## 1 Strategic issues

Inner West Council has a long-standing position of opposing inner-city motorways such as WestConnex, preferring public and active transport solutions to Sydney's traffic problems. Modification 2 expands the footprint of WestConnex and is opposed by Council. Council is also concerned that one of the major justifications for the modification is access to a possible future motorway project (the Western Harbour Tunnel (WHT)) that is also opposed by Council and has not yet been approved.

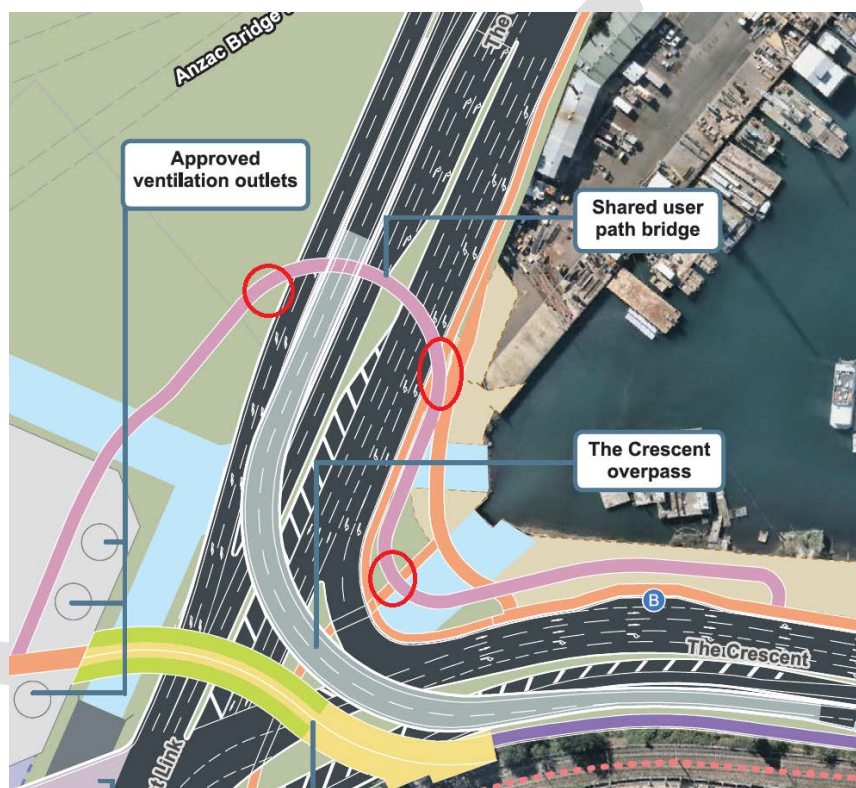
- 4 The shared path linking the former Buruwan Park and Johnston Street, beside the community mural, be maintained and widened.
- 5 All shared paths adjacent to roadways be buffered with the installation of mature trees and landscaping providing shade and pollution filters.
- 6 A new section of shared path be provided along The Crescent, adjoining the existing timber business and beyond the bridge piers - connecting Chapman Road and the City of Sydney's soon-to-be-constructed path at the pedestrian refuge and ramp.
- 7 On the proposed shared user path, stairs be provided to minimise unnecessarily long and circuitous walking distances and provide an opportunity for people to exit the overbridge quickly and gain the attention of passing motorists if they feel unsafe.

Suggested stair locations are shown below and should account for future pedestrian movements resulting from revitalisation of the Bays Precinct. The connections should be legible and direct to provide faster walking access for people who can use them.
